ECK 5TH ADDITION

WICHITA, SEDGWICK COUNTY, KANSAS

Re: S/D 97-70 One-Step Final Plat Of ECK 5TH ADDITION

STAFF REPORT
(One-Step Final-Approved 9/18/97)

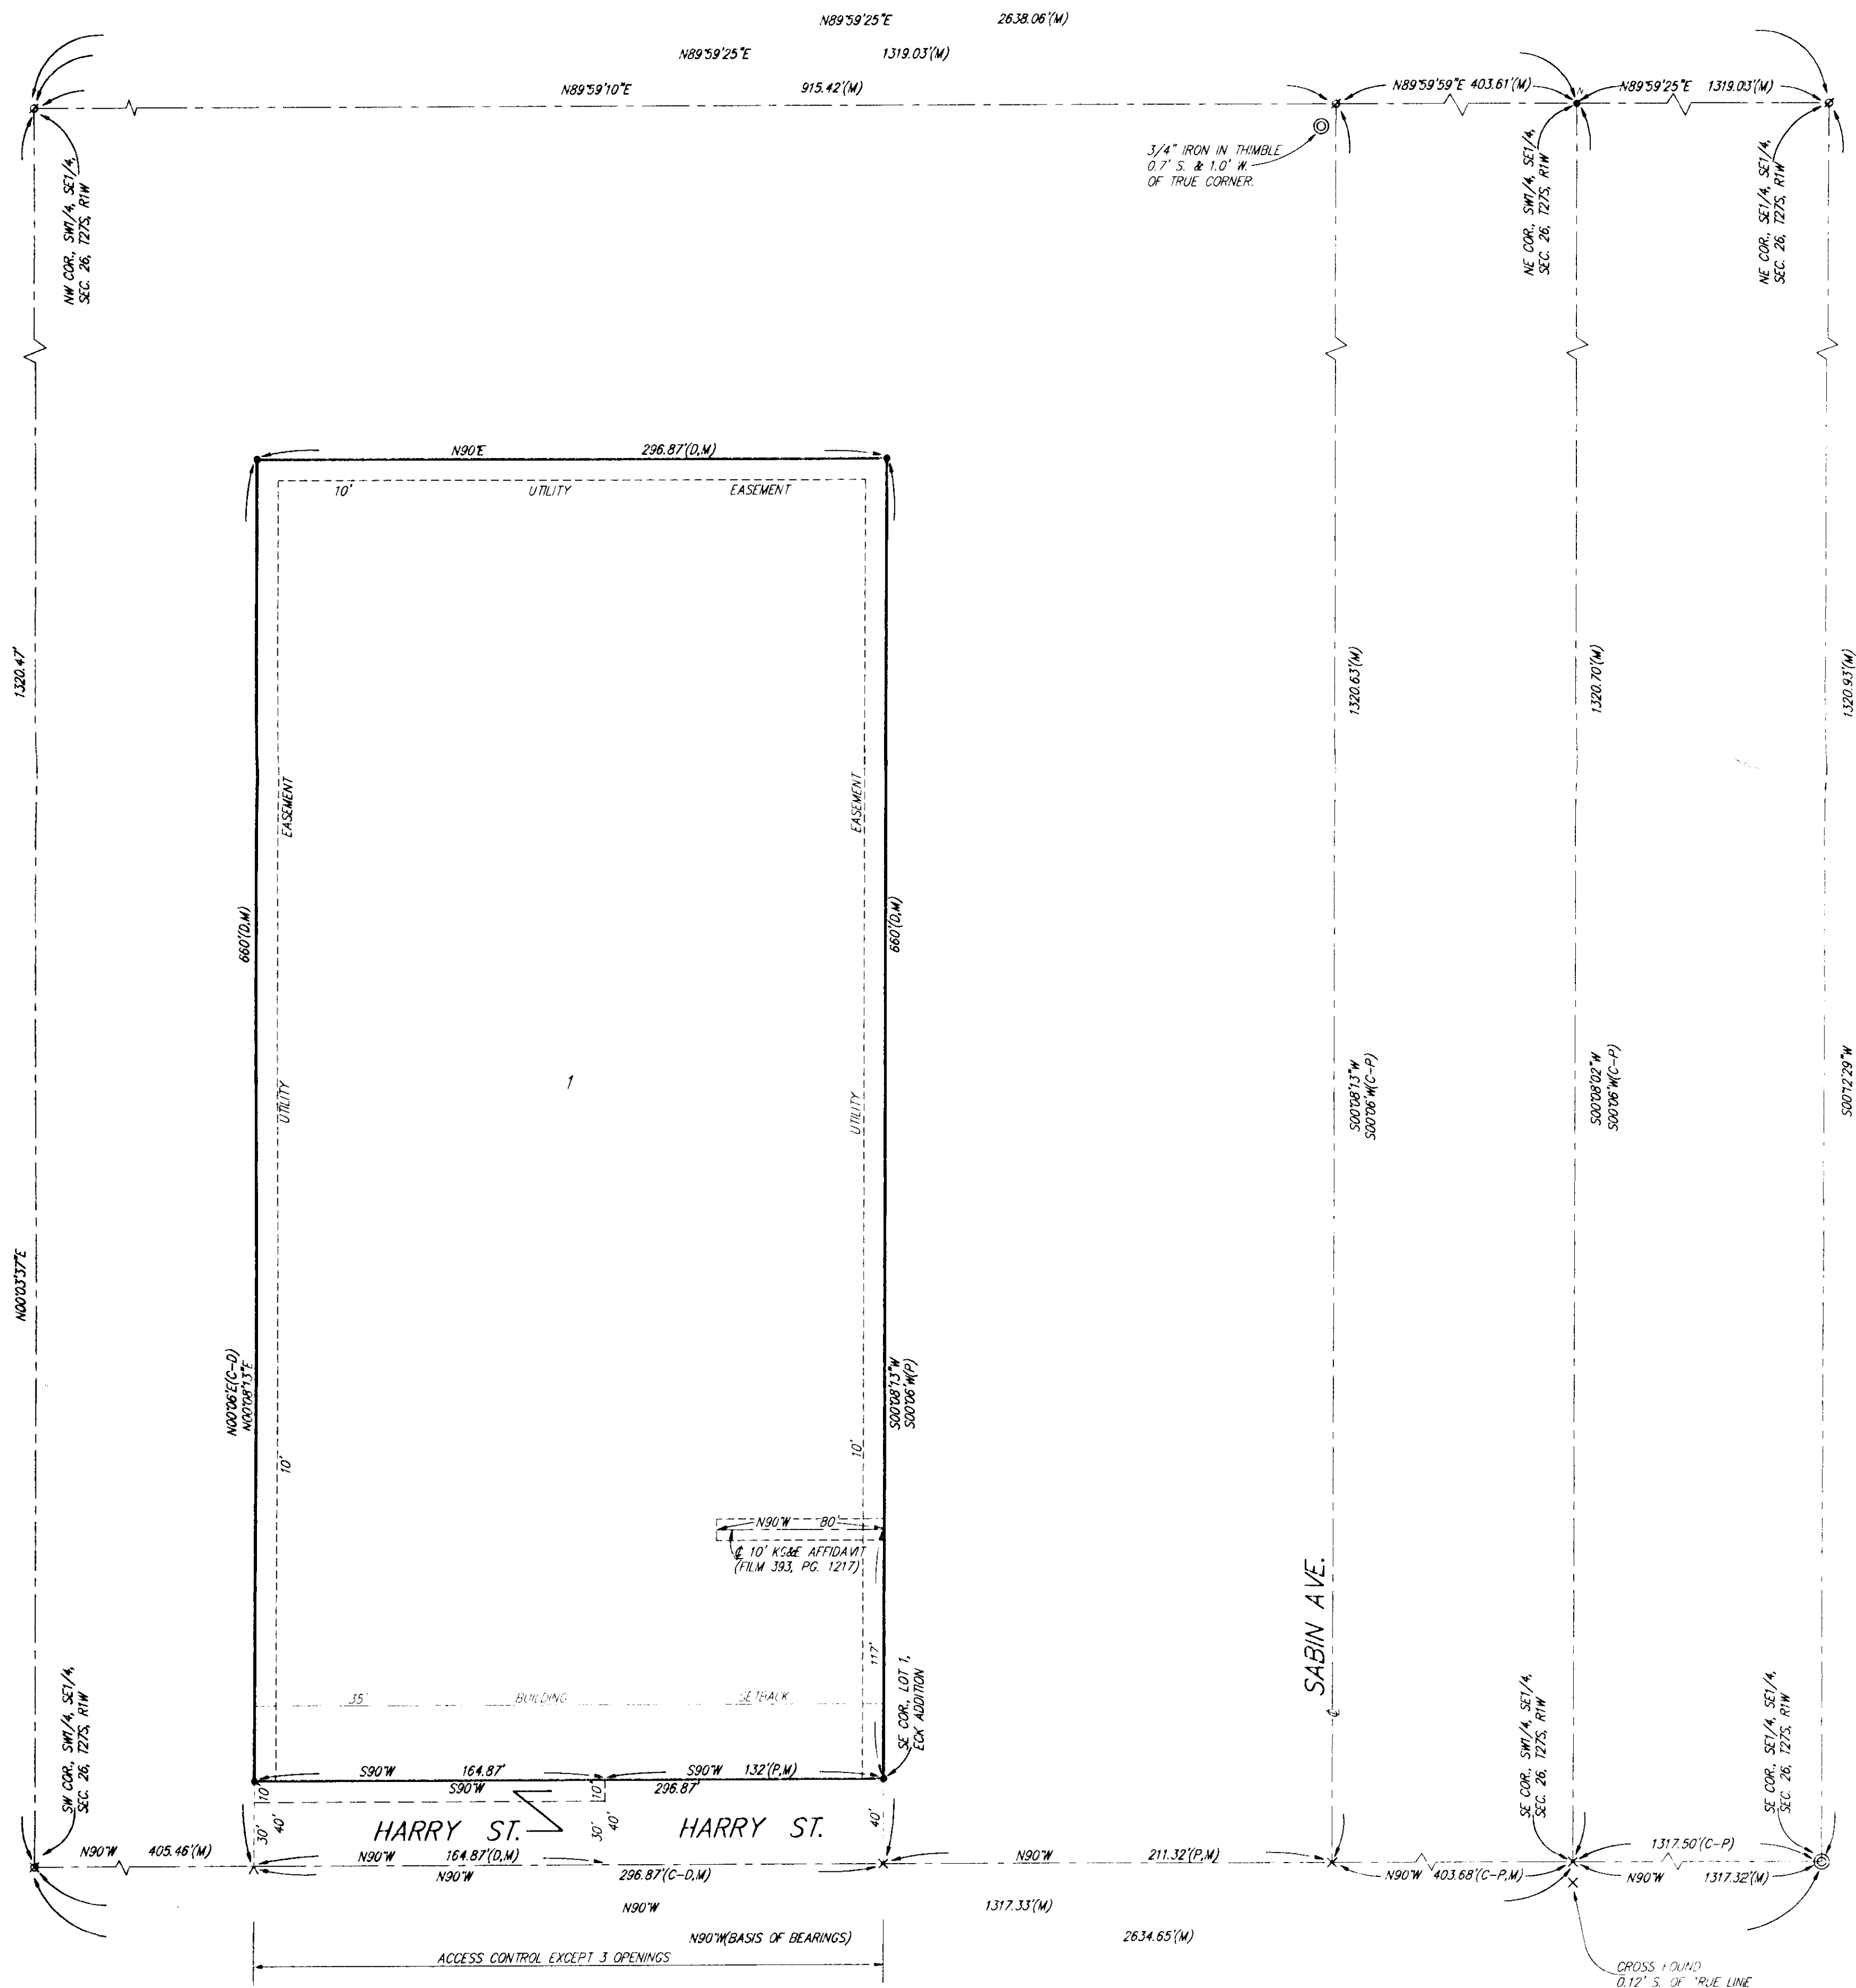
- M. The scale should be corrected on the final tracing. The preliminary plat has a scale of 1 inch equals 50 feet and the final plat has a scale of 1 inch equals 100 feet. Both drawings are the same size but have different scales are shown on the plat.

- N. The distances from the tie point to the point of beginning do not correlate with those in the plat's text. Before the final tracing is submitted this should be corrected.

- M. The scale should be corrected on the final tracing. The preliminary plat has a scale of 1 inch equals 50 feet and the final plat has a scale of 1 inch equals 100 feet. Both drawings are the same size but have different scales are shown on the plat.

- N. The distances from the tie point to the point of beginning do not correlate with those in the platter's text. Before the final tracing is submitted this should be corrected.
